**MINUTES
BOARD OF ZONING APPEALS
REVIEW MEETING
LAKEWOOD CITY HALL
AUDITORIUM
FEBRUARY 15, 2024
6:30 P.M.
MEETING IS RECORDED
<https://www.lakewoodoh.gov/videos-2/>**

**4. Docket No. 12-19-23
12500 Edgewater Dr.
The Waterford Condominiums**

5. **Docket No. 02-05-24**
1352 Kenilworth Ave.

6. Docket No. 02-06-24 1062 Leedale Ave.

PLAT OF LOT SPLIT AND CONSOLIDATION FOR RDS INVESTMENT, LLC

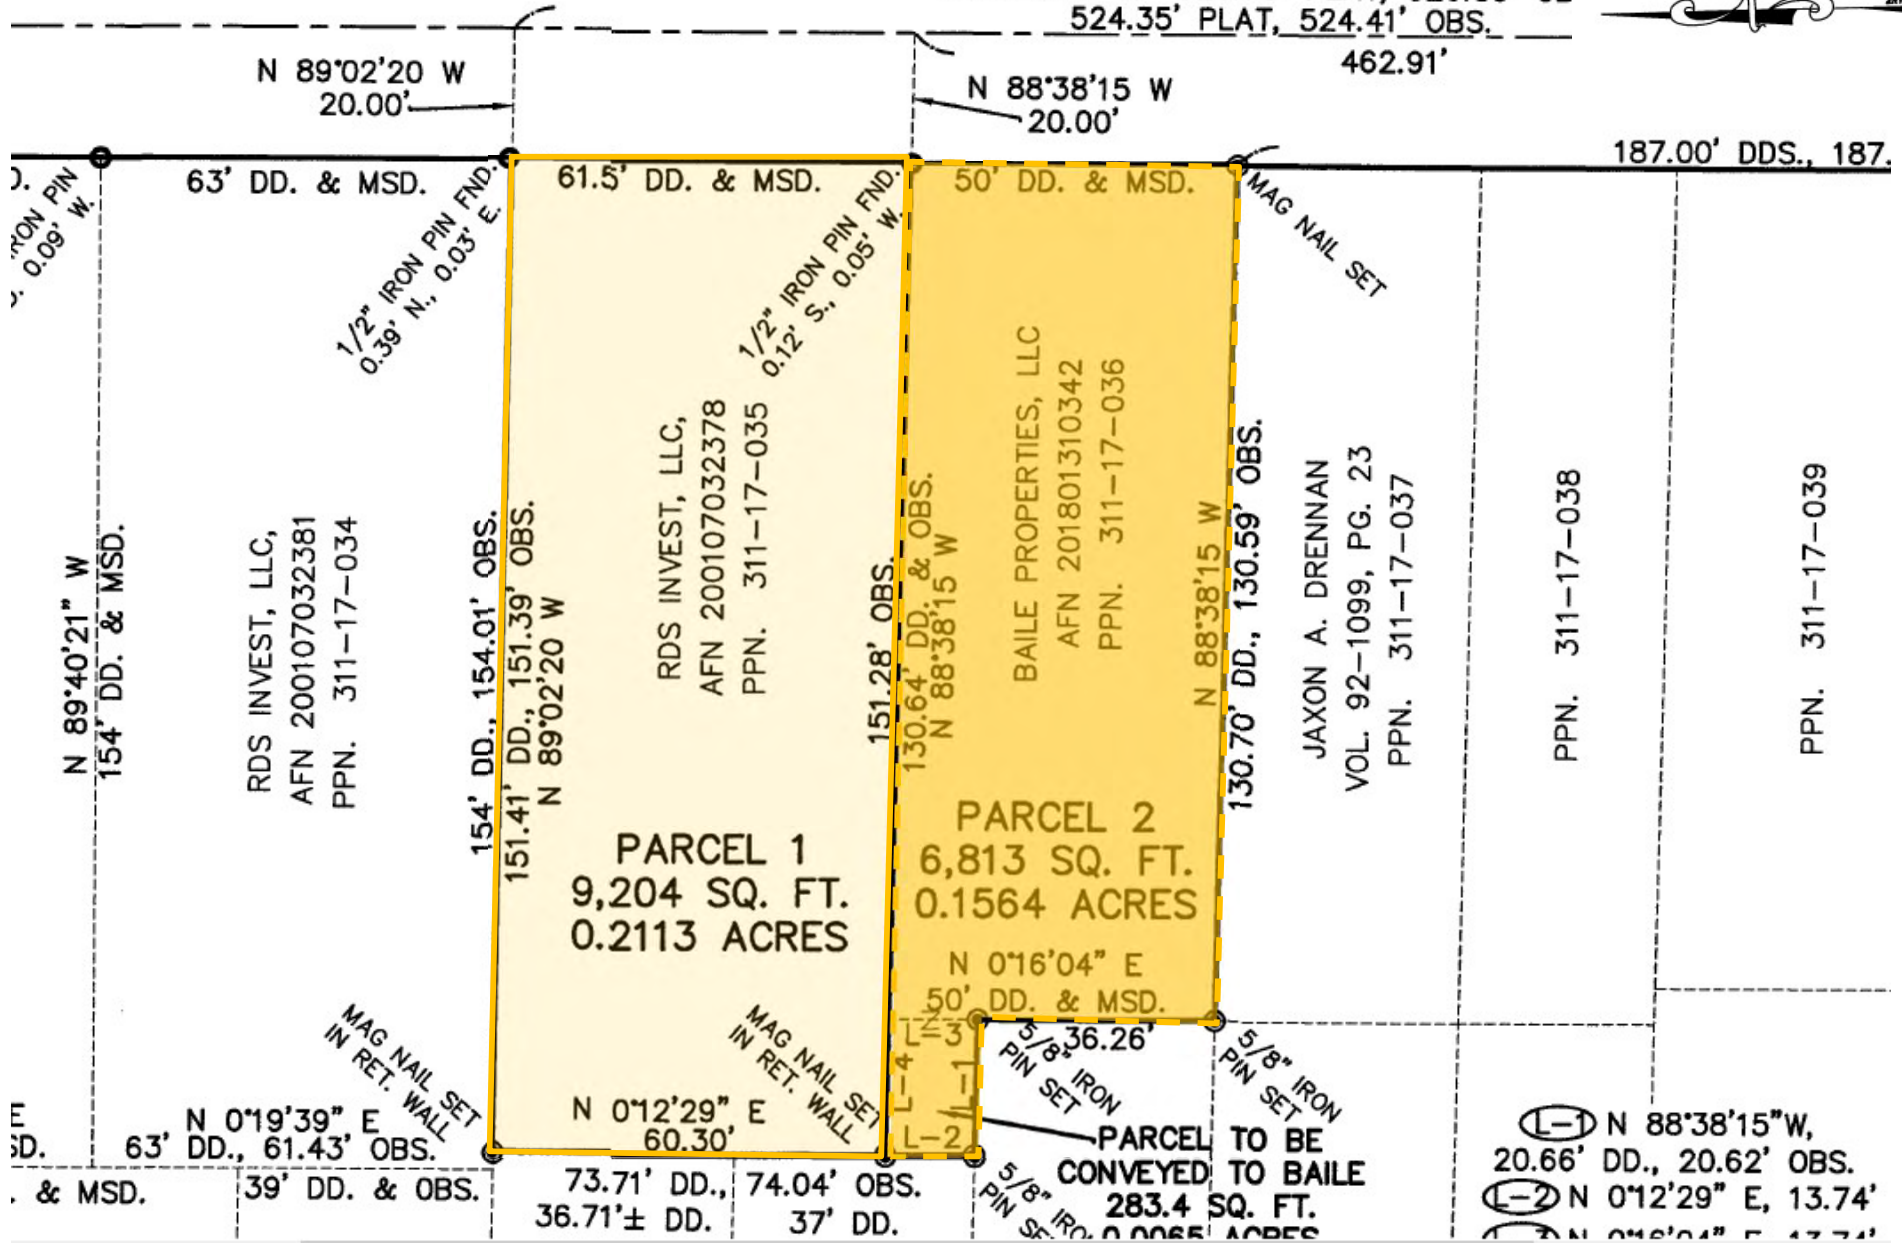
- Variance 1: Per a survey provided by the current owner, the existing masonry garage is 1.2 inches from the western property line. The required minimum setback for a masonry garage is 6 inches. Request a variance for the garage location and the property line to remain unchanged on the west side of the property at 1.2 inches when this portion of the parcel is split from 1352 Kenilworth Ave. and added to 1356-58 Kenilworth Ave, as proposed. Pursuant to 1121.10(a)(1 ADDITIONAL ACCESSORY STRUCTURE REGULATIONS (Ord. 32-16. Passed 9-6-2016.)

- Variance 2: Per a survey provided by the current owner, the existing masonry garage is 4.8 inches from the northern property line. The required minimum setback for a masonry garage is 6 inches. Request a variance for the property line and garage to remain unchanged on the north side of the property at 4.8 inches when this portion of the parcel is split from 1352 Kenilworth Ave. and added to 1356-58 Kenilworth Ave, as proposed. Pursuant to 1121.10(a)(1 ADDITIONAL ACCESSORY STRUCTURE REGULATIONS (Ord. 32-16. Passed 9-6-2016.)

- Lot Split and Consolidation request has been heard and approved by Planning Commission, contingent on BZA approval of two minor area variance requests.
- The garage is existing, it will not be any further or closer to the property lines than it has been for at least 30 years
- New owners will assume violations to repair.

A motion was made by Ms. Bolino, seconded by Mr. Pigott to **APPROVE the request for two variances as proposed**. Mr. Alexander, Ms. Bolino, Mr. Markling, Mr. Pigott, and Mr. Santiago voted yea; the motion passed.

1062 Leedale

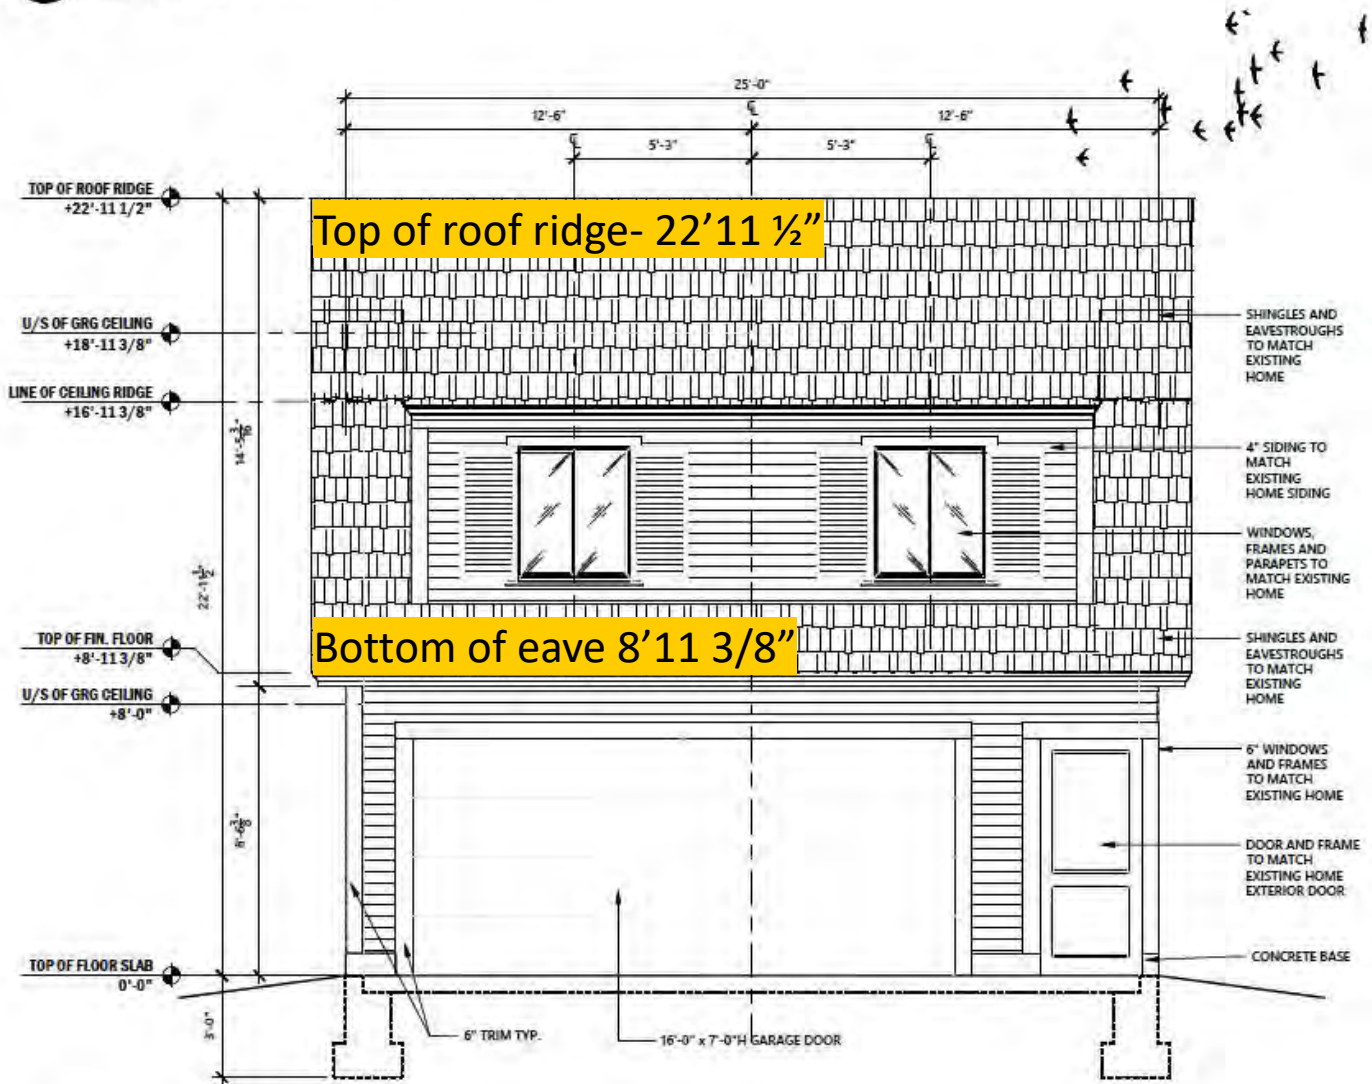
Back Yard width 40'0"

Side and rear setback- 1'6" as proposed

Rear Yard- 51' x 40'=2,040sqft
25% of 2,040=510 sq ft
Proposed is 550 sq ft or 27%

Back yard depth 27'6"+22'+ 1'6"= 51' depth

- The original proposal submitted was a gable style roof that would require a 6 ½ foot height variance. The applicant amended request and submitted a mansard-style roof which reduces the height request to 11” above the 15’ permitted.
- Plans say “existing garage to be expanded” applicant please explain what parts of garage are to be reused?
- The lot is 4,600 sq. ft, the minimum size of a lot in R1H district is 5,000, lot is undersized by today’s zoning requirements, no room to expand horizontally without a variance.
- Abutting adjacent neighbors have single story garages
- Surrounded by other residential properties

A motion was made by Mr. Pigott, seconded by Mr. Markling to **APPROVE the request for two variances as proposed**. Mr. Alexander, Mr. Markling, Mr. Pigott voted yea, and Ms. Bolino and Mr. Santiago voted nay; the motion passed.
